**CITY OF PORTLAND, MAINE
DEVELOPMENT REVIEW APPLICATION
PLANNING DEPARTMENT PROCESSING FORM**

PLANNING BOARD REPORT #38-98

Major Site Plan Application
I&R Associates, Riverside Industrial Parkway

RE: Site Plan Review
I & R Associates
Riverside Industrial Parkway

General Notes:

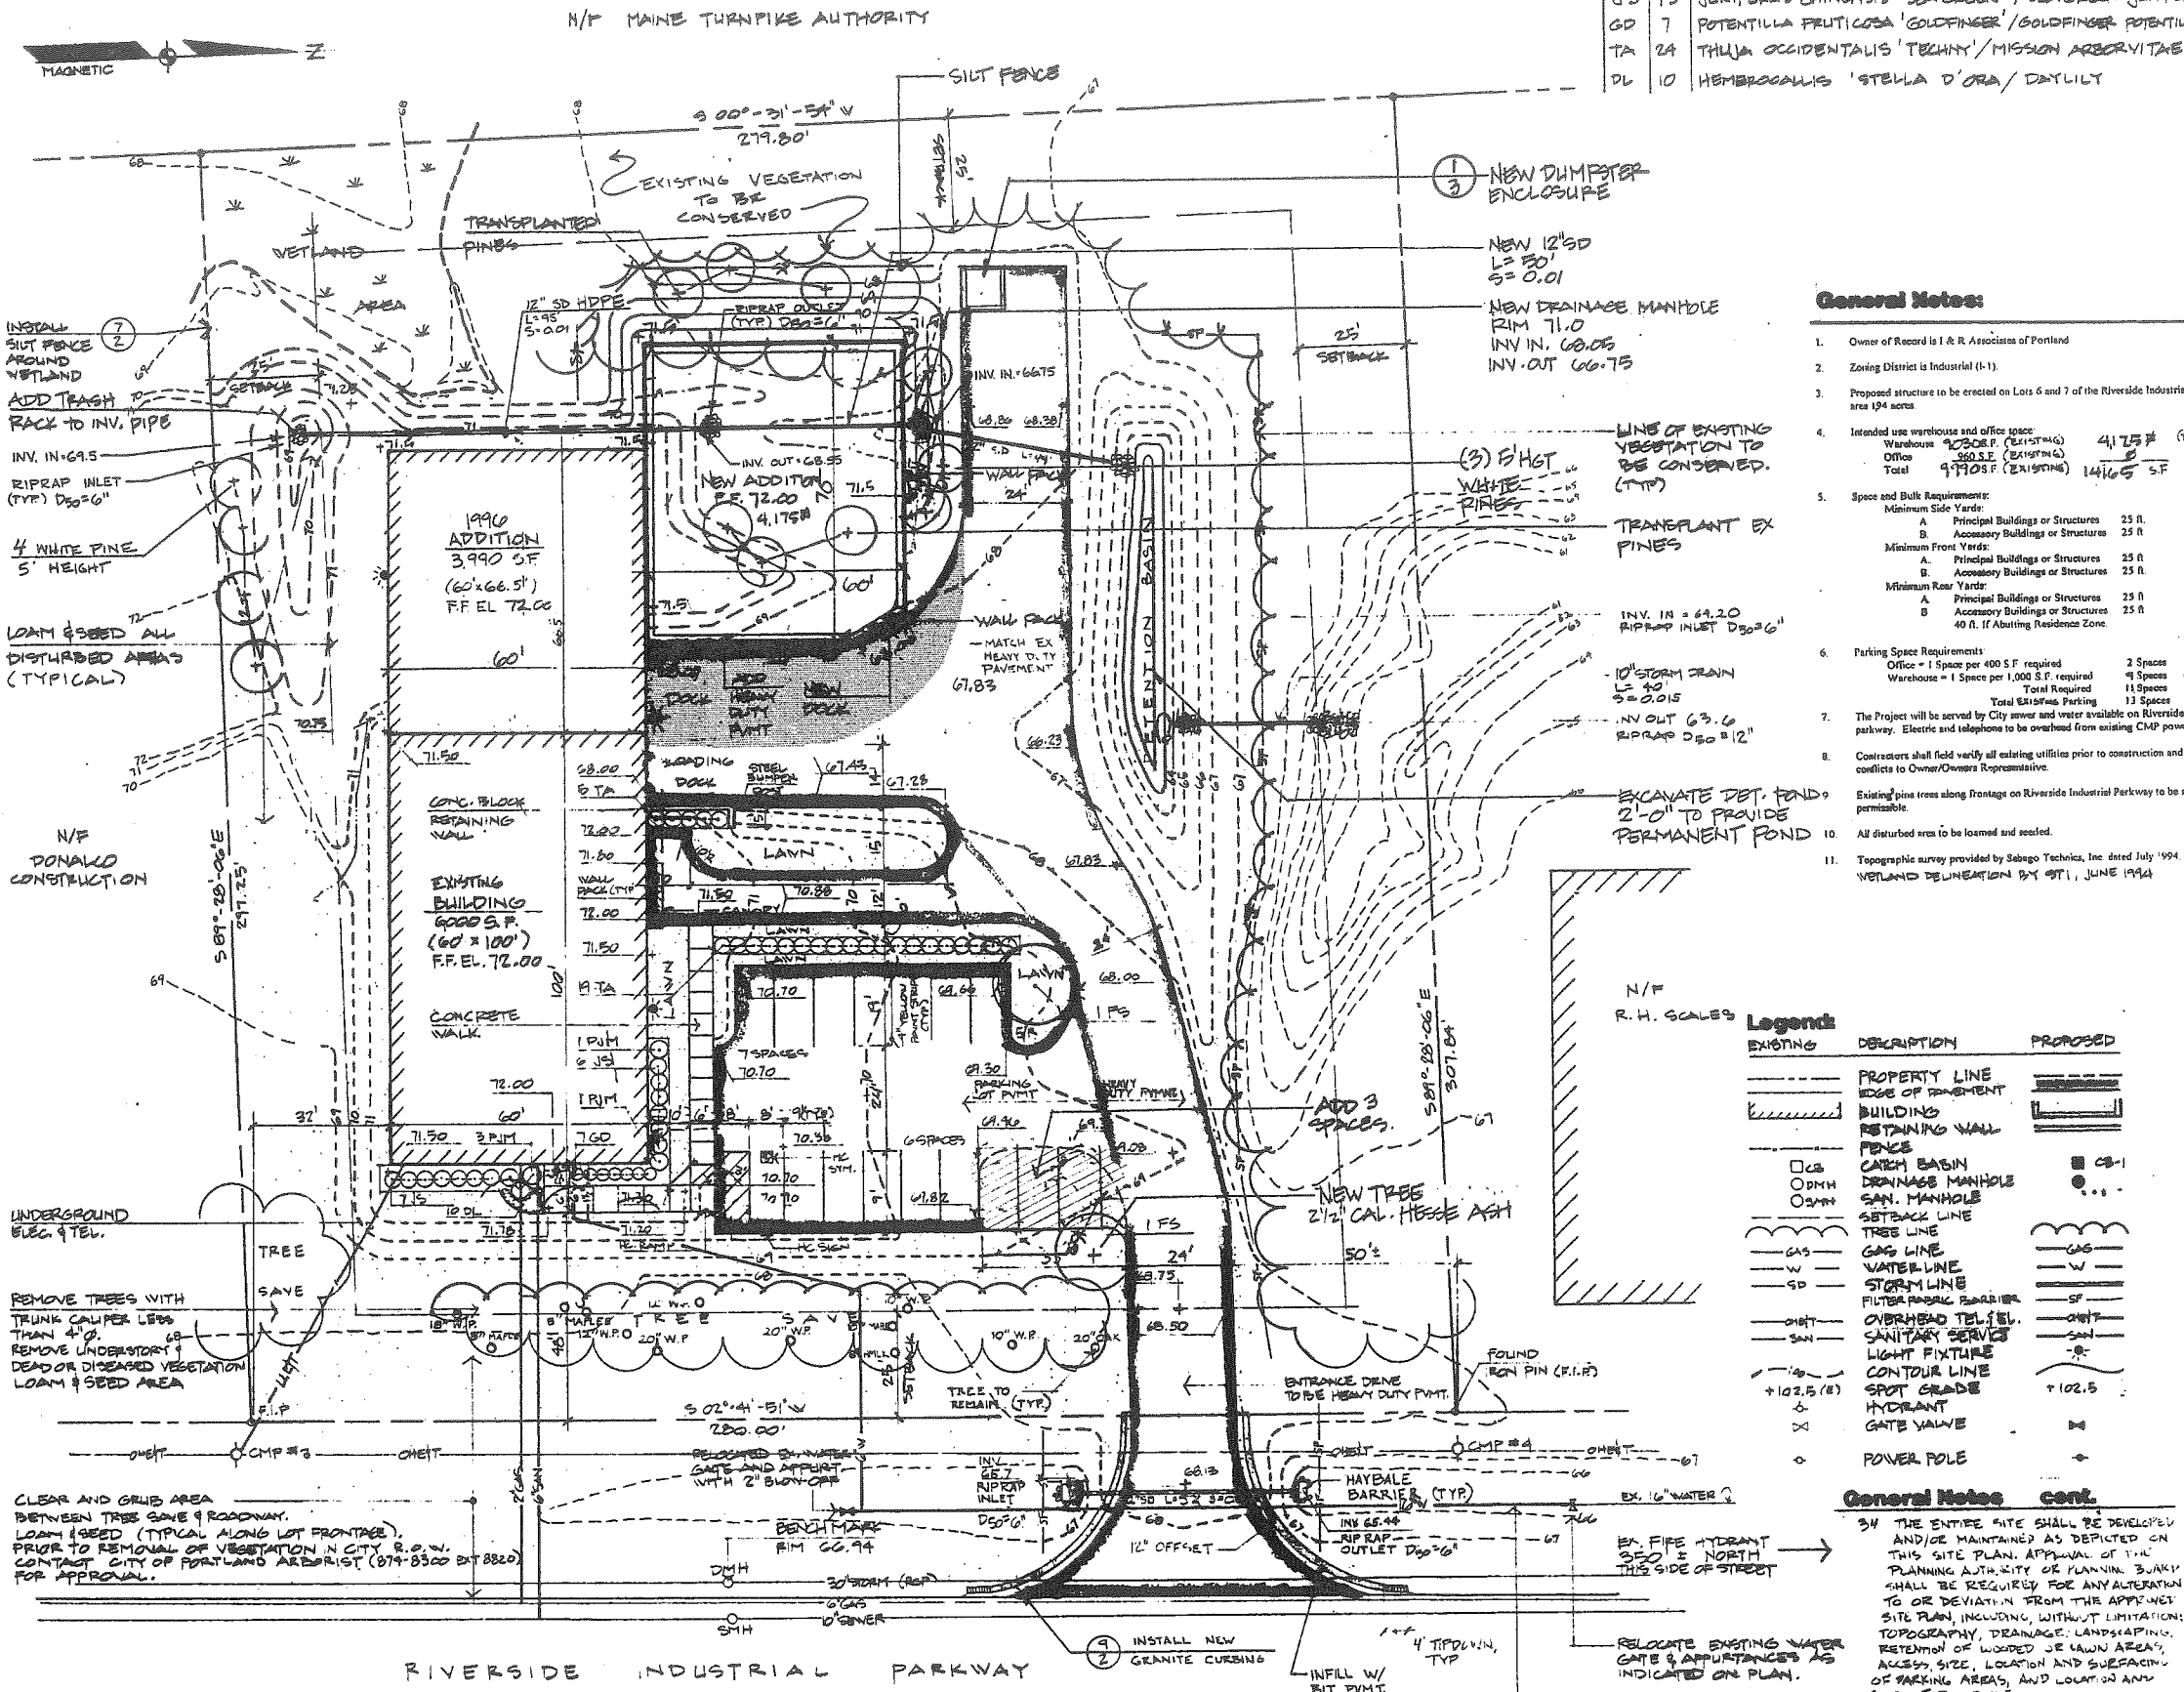
8. The existing roof has a ridge that splits the width of the building. Please provide a plan of the proposed building expansion that shows the new location of the ridge line for watershed 11. This watershed would not have the identical output for the present and post conditions. There should also be a shallow concentrated flow component for the T_c calculation.

9. The discussion for erosion control measures is very vague. Please provide the detail sheet that outlines the erosion control requirements.
10. In an effort to promote water quality, recommend that the bottom of the detention basin be lowered by 2' to create a permanent pond.

Items 1-8, 11 noted in my previous correspondence dated August 4, 1998 have been satisfactorily revised. However, the submission package received did not include a revised site plan; therefore review of responses for items 9 and 10 of the referenced correspondence was not possible.

Items 9, 10 in my previous correspondence dated August 4, 1998 have been satisfactorily revised. There are no further comments.
